**From:** SM-Defra-RESP-notifications (DEFRA)  
**Sent:** 15 September 2023 11:17  
**To:** George Seinet  
**Cc:** Wray, Kate  
**Subject:** EPR/HP3931YF/V004 - Weston Poultry Unit - Additional information required CRM:0278041  
**Attachments:** Raw Materials List.xls; Dust management plan.docx; Operating techniques.pdf

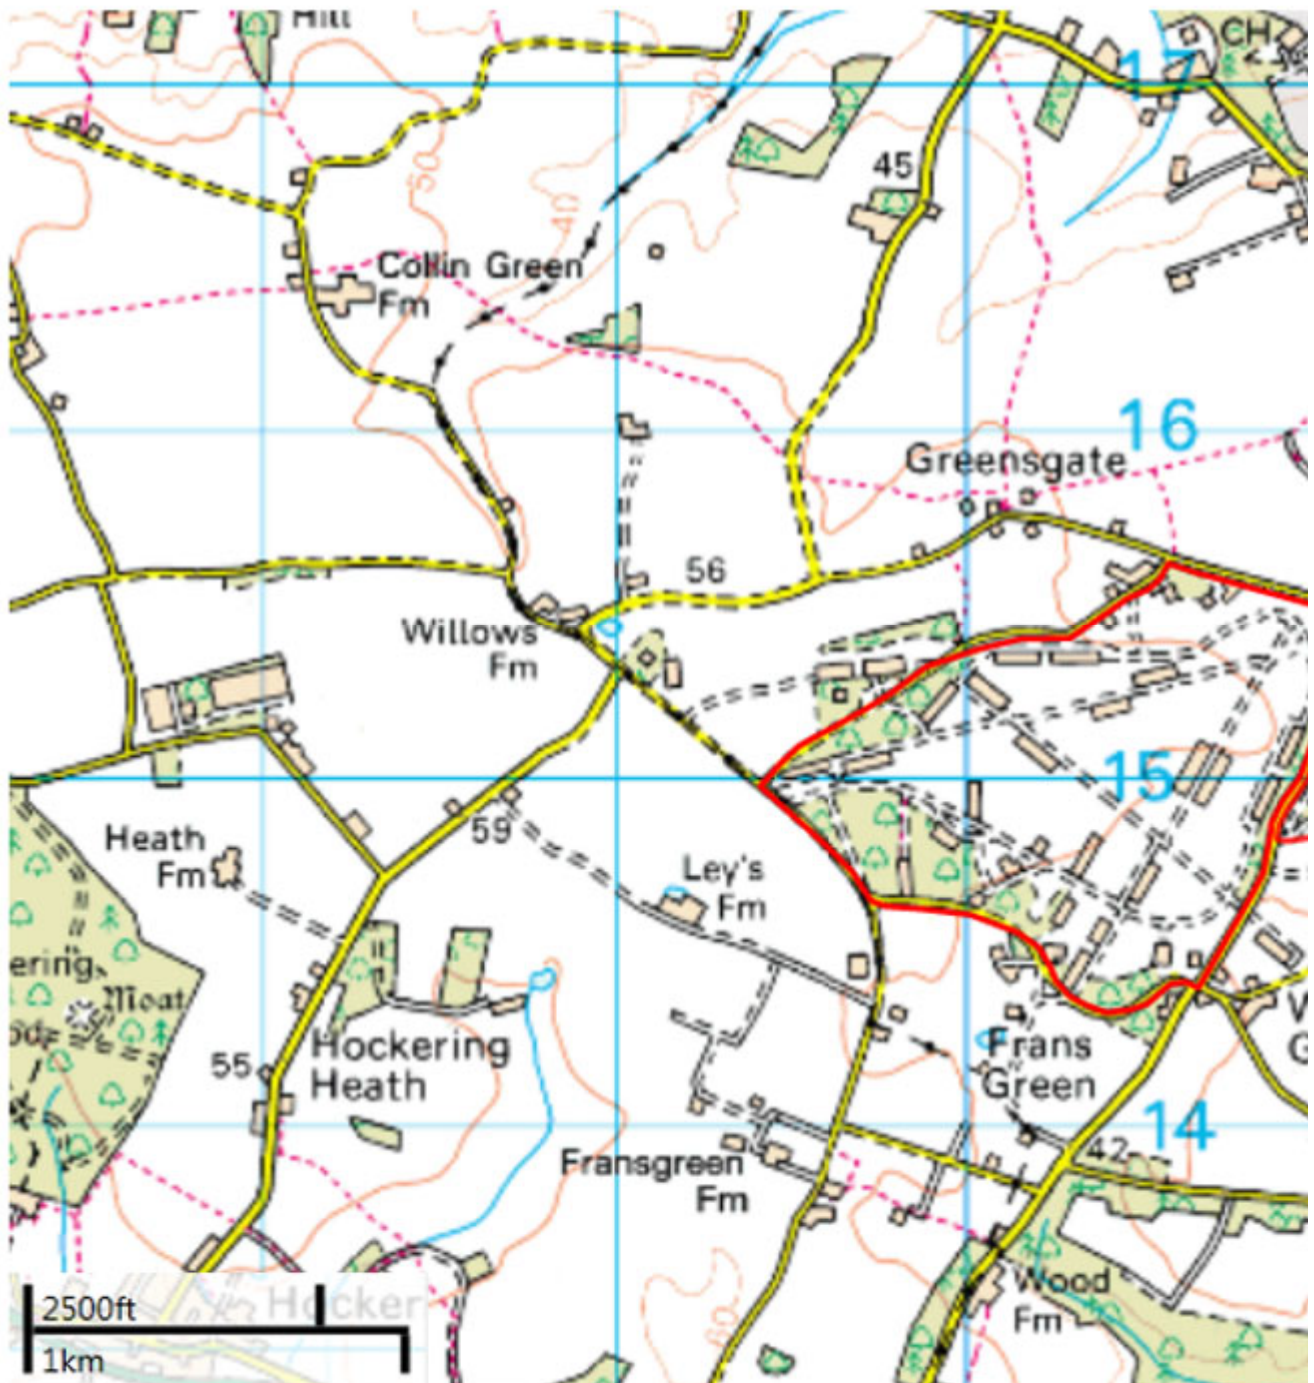
I have reviewed the revised installation boundary plan and can see you have removed the residential receptors from the boundary. Can you confirm whether any operations relating to the installation have been carried out on any of these areas of land in the past please?

Can you submit a revised boundary plan in OS format or similar please, as with the current boundary plan (see below), as the CAD drawing is not suitable to include in schedule 7 of the permit. You will need to include the installation boundary, clearly shown in green if possible, the numbered poultry houses, a scale and north arrow. The revised plan needs to reflect the boundary below but remove the areas where the residential properties are located as you have done on the CAD drawing. There appears to be an additional area of land shown on the CAD drawing which is not part of the current permitted boundary so can you make sure this is not included on the revised plan please:

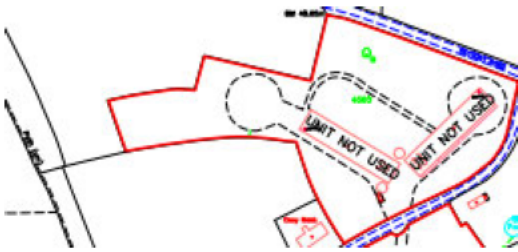
In terms of the site drainage plan, can you amend the CAD drawing to clearly show the installation boundary, in green if possible, drainage route for each separate poultry house to the dirty water tanks in red and the drainage route of uncontaminated roof and yard water for each poultry house to soakaway in blue, as described in the current permit, along with the location of the fuel tanks, feed silos, standby generator, and ventilation fans on each house (roof and side). Again, can you make sure it is clear on the drawing that the area of land below is not part of the installation boundary:
